ID - B-2214

STATE OF NORTH CAROLINA
DEPARTMENT OF TRANSPORTATION
PLAN AND PROFILE OF PROPOSED
STATE HIGHWAY

FORSYTH COUNTY

LOCATION: BRIDGE OVER I-40 AND US 421 WITH APPROACHES
ON NC 150 AT WEST CITY LIMITS OF KERNERSVILLE
TYPE OF WORK: GRADING, PAVING, DRAINAGE, STRUCTURE, LANDSCAPE,
WIDENING, SNOWPLOWABLE PAVEMENT MARKERS &
THERMOPLASTIC PAVEMENT MARKINGS

PROJ. REFERENCE NO.	SHEET NO.	TOTAL SHEETS
B.1621801	5	
STATE PROJ. NO.	F. A. PROJ. NO.	DESCRIPTION
B.1621801

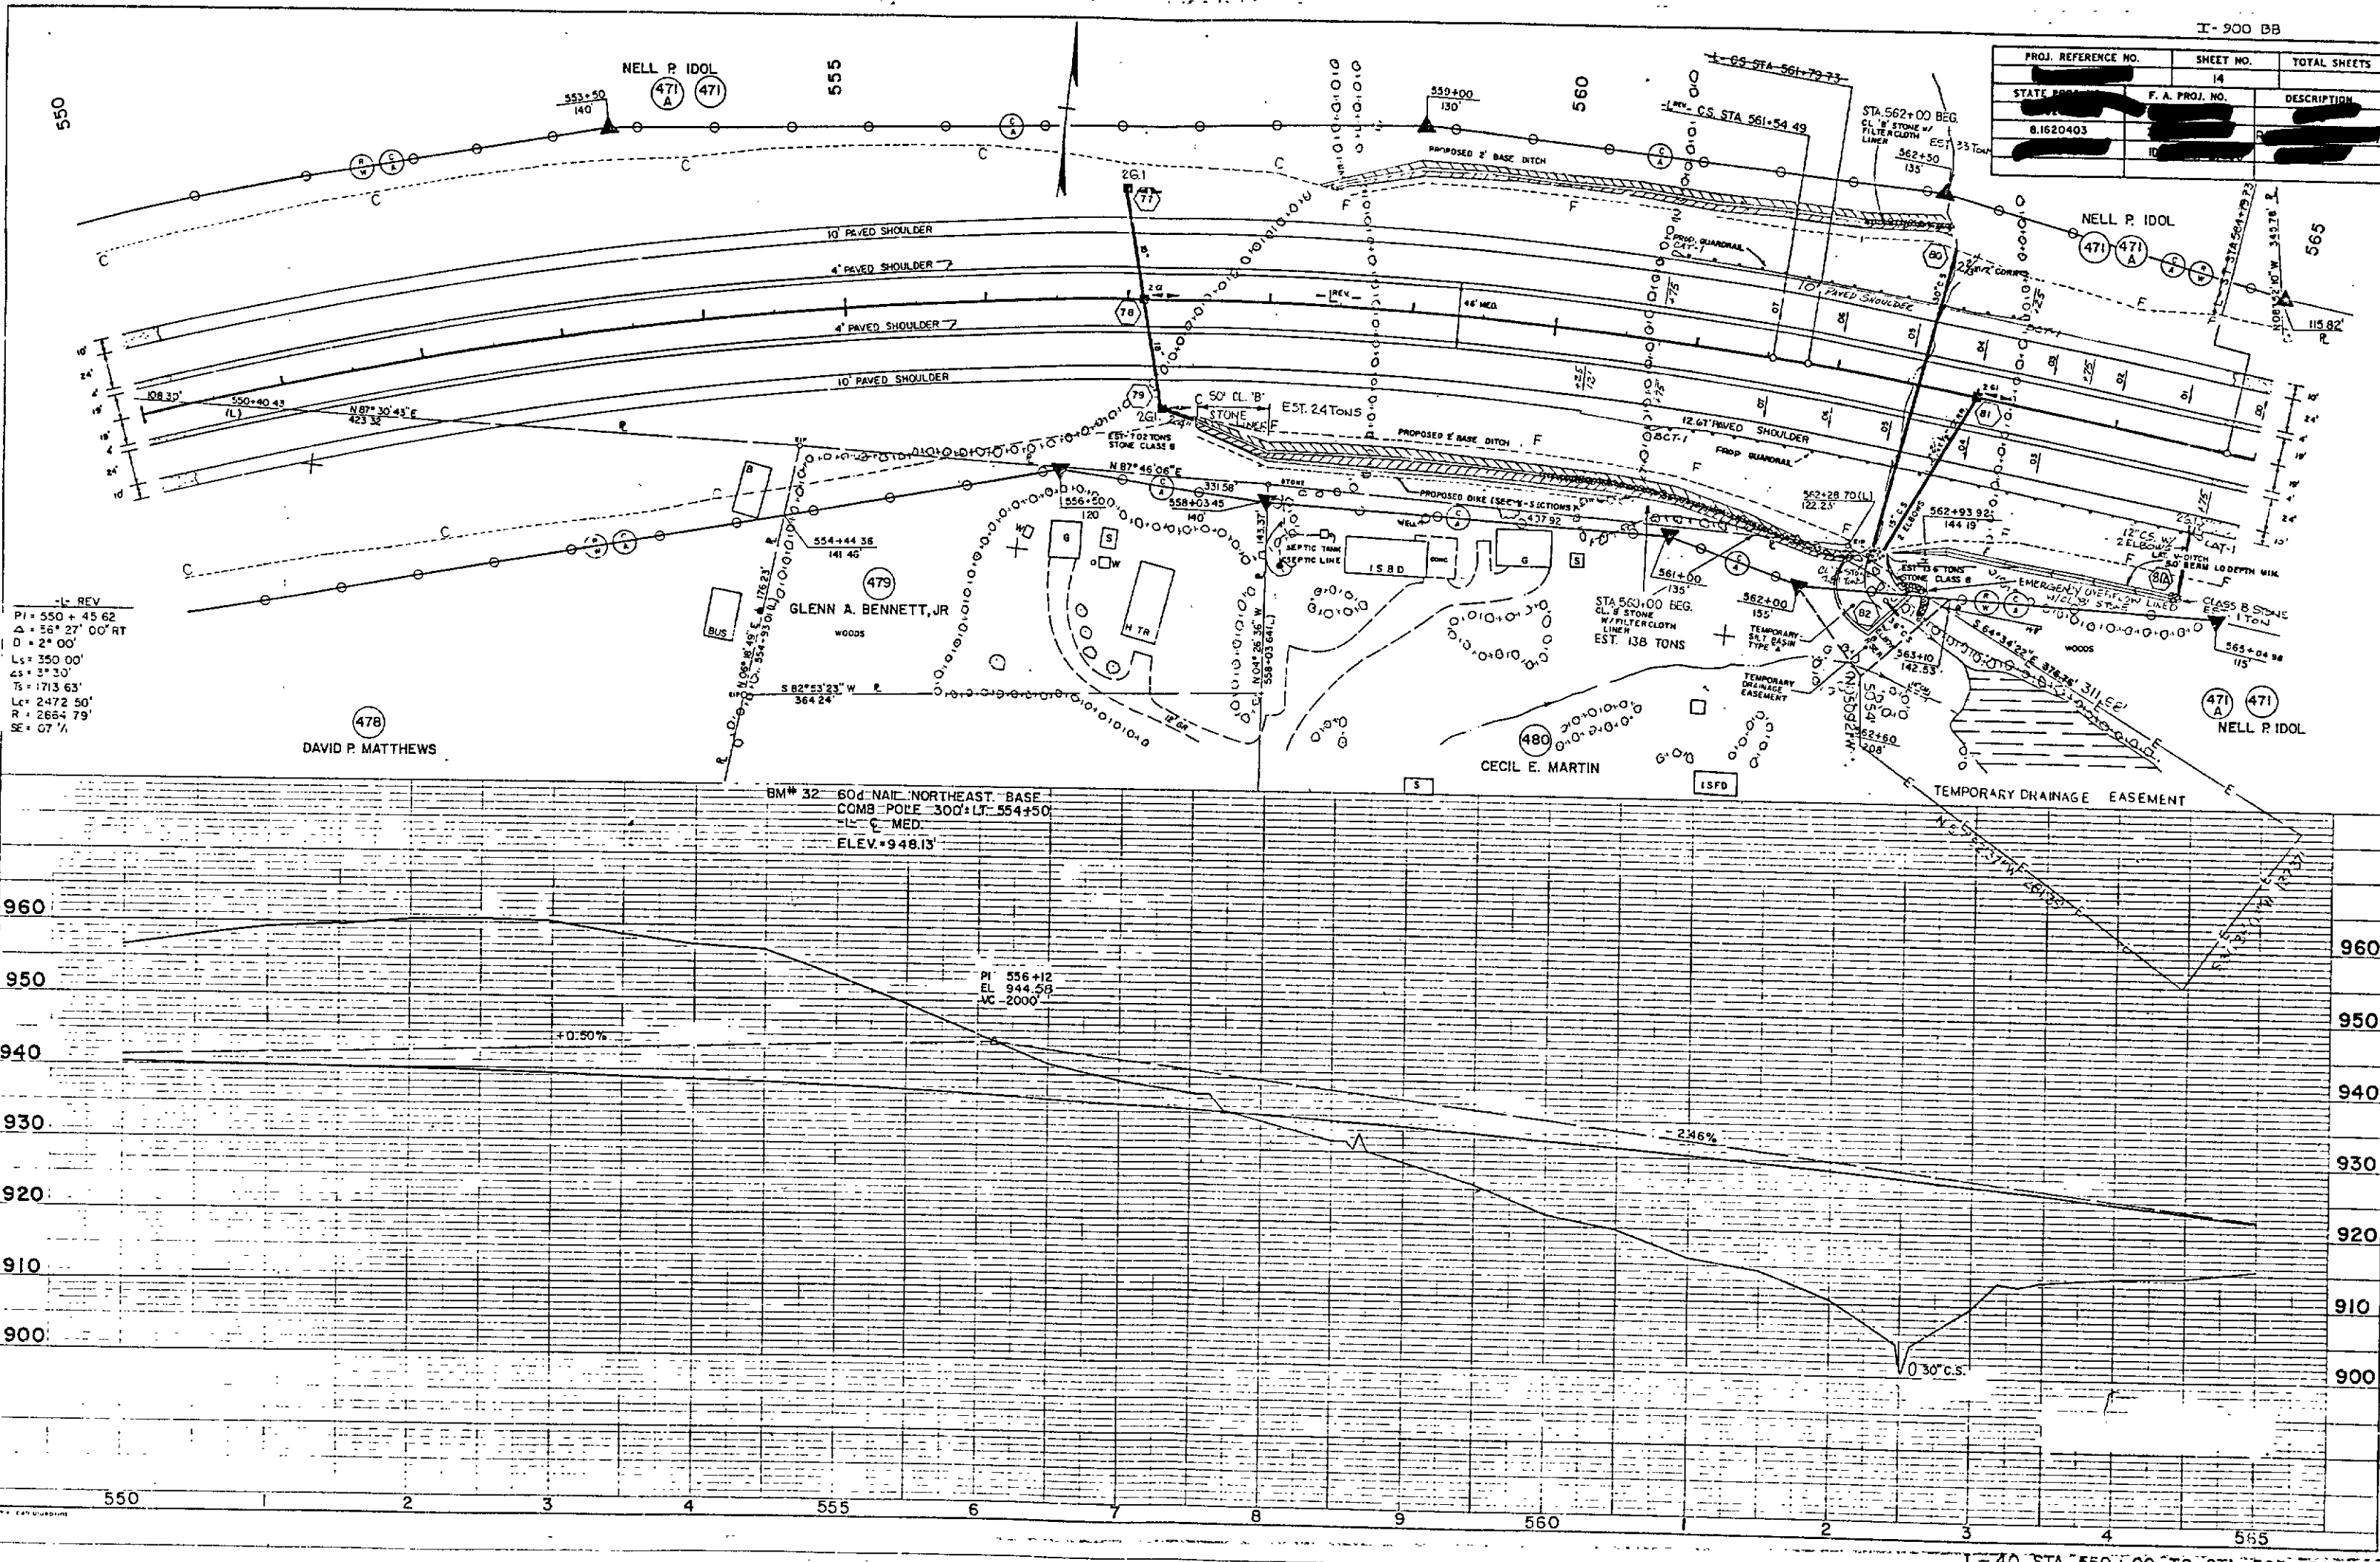
PLAN
R/W REV. 9-27-91
PARCEL 480 INCREASE TEMP.
DRAIN. EASE. M.S.D.
